Special Use Permit #2024-00041
404-A East Alexandria Avenue

Application	General Data	
Public Hearing and consideration of requests for Special Use Permits to construct a single-unit dwelling on a vacant substandard lot and for a lot without frontage on a public street	Planning Commission Hearing:	November 7, 2024
	City Council Hearing:	November 16, 2024
Address: 404-A East Alexandria Avenue	Zone:	R-2-5/ Residential
Applicant: Eric Teran and Daniela Gross	Small Area Plan:	Potomac West

Staff Recommendation: APPROVAL subject to compliance with all applicable codes, ordinances, and the recommended permit conditions found in Section III of this report.

OPTION 3

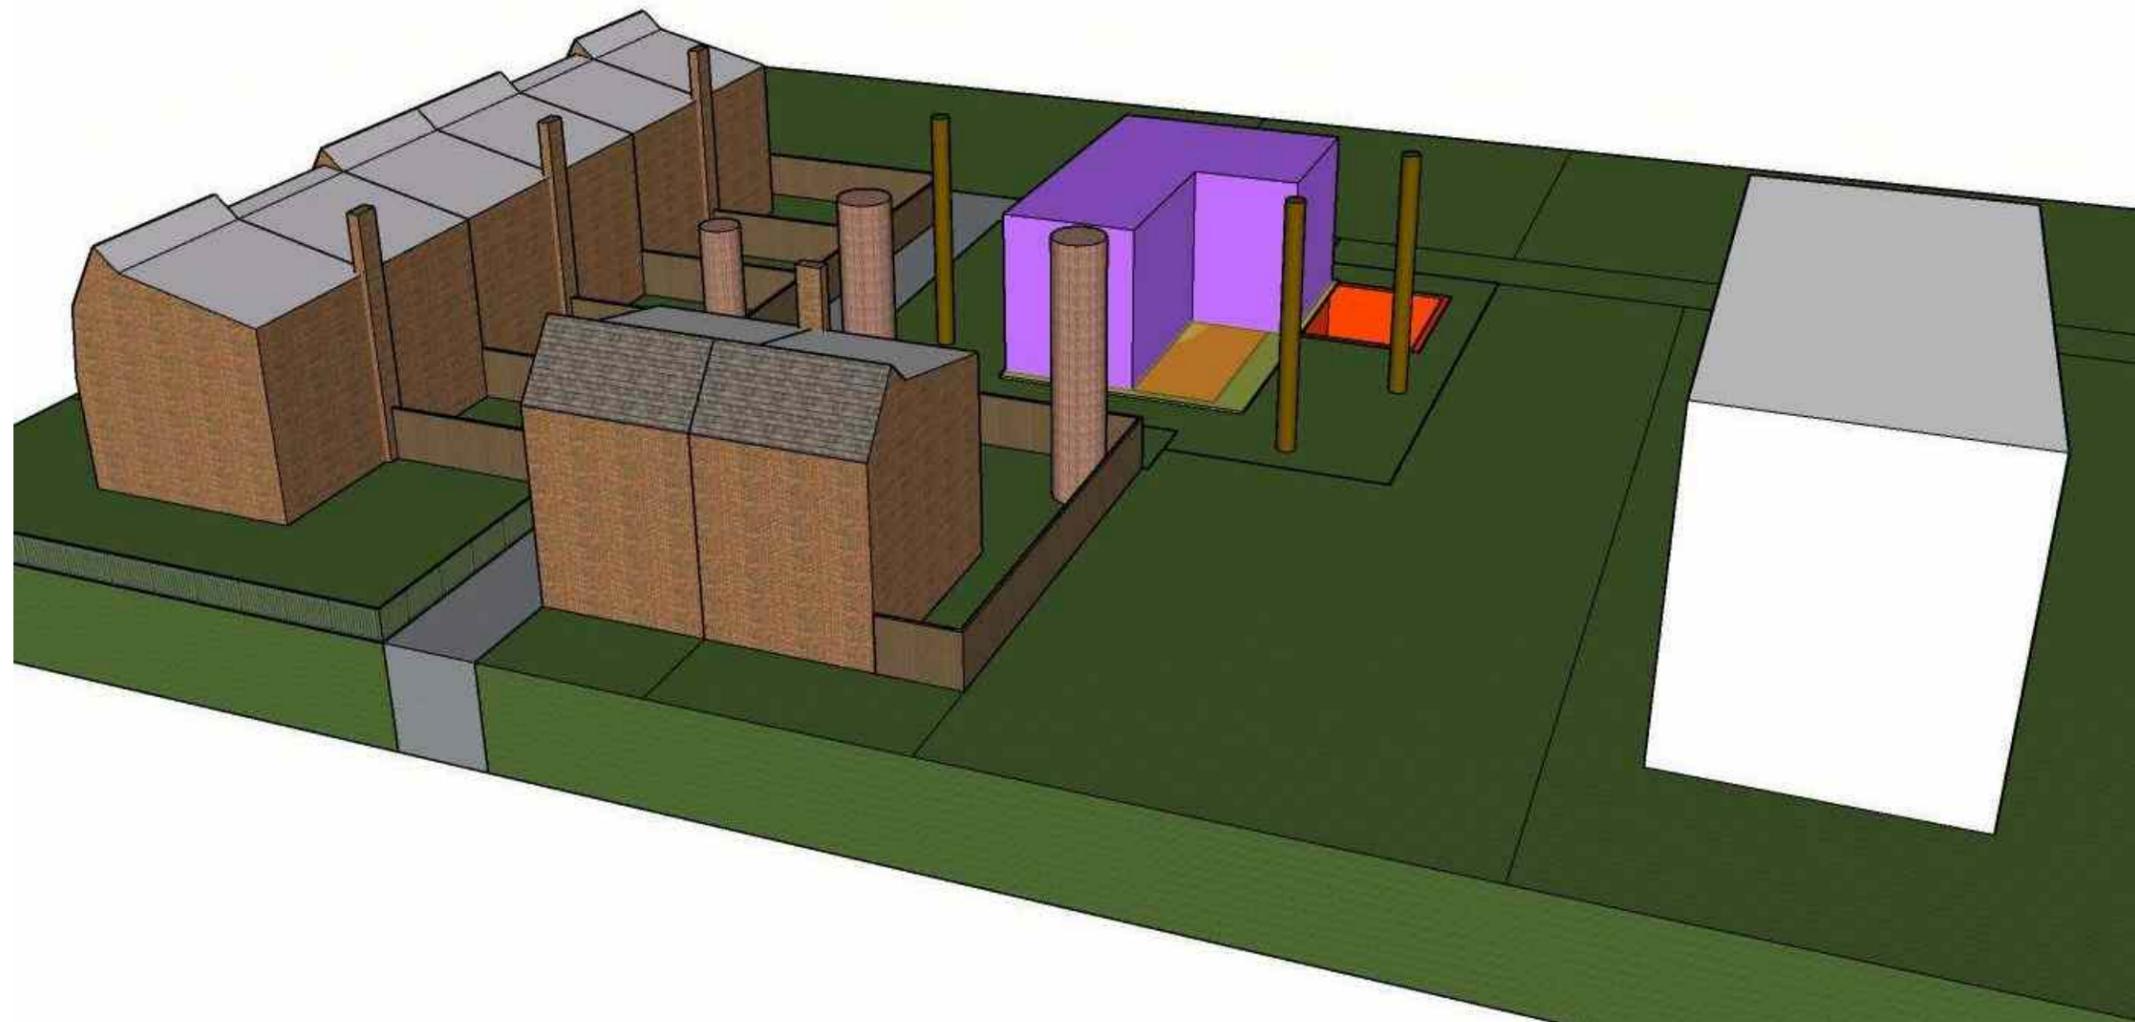
1. NEW LOT SIZE PER APPROVED VACATION REQUEST
2. MAINTAIN ORIGINAL BASEMENT DESIGN
3. PROTECT EX. SILVER MAPLE TREE

1. REMOVE THE SILVER MAPLE TREE AND PLANT 3 - 4 NEW TREES

2. THE BASEMENT IS RECONFIGURED AND CONTAINED WITHIN THE ABOVE GRADE BUILDABLE AREA.

1. THE ABOVE GRADE FLOORS ARE SHIFTED TO THE EAST PROVIDING A SETBACK OF 18'-0" FROM THE ALLEY. THE ORIGINAL DESIGN IS 7'-0".

1. THE HOUSE IS MORE VISIBLE FROM E. ALEXANDRIA AVE.

1. THE FRONT YARD IS ON THE WEST SIDE OF THE PROPERTY CREATING A DIFFERENT BUILDABLE AREA
2. REMOVE THE SILVER MAPLE TREE AND PLANT 3 - 4 NEW TREES
3. THE BASEMENT IS RECONFIGURED AND CONTAINED WITHIN THE ABOVE GRADE BUILDABLE AREA.

2. THE SOUTH FACADE IS NOW ONLY 9'-0" FROM THE PROPERTY LINE COMPARED TO 19'-10" IN THE ORIGINAL DESIGN.

3. THE "L" SHAPE PROVIDES LESS VISIBILITY FROM E. ALEXANDRIA AVE.

1. THE "L" SHAPE AND VEGETATION PROVIDES LESS VISIBILITY FROM E. ALEXANDRIA AVE.
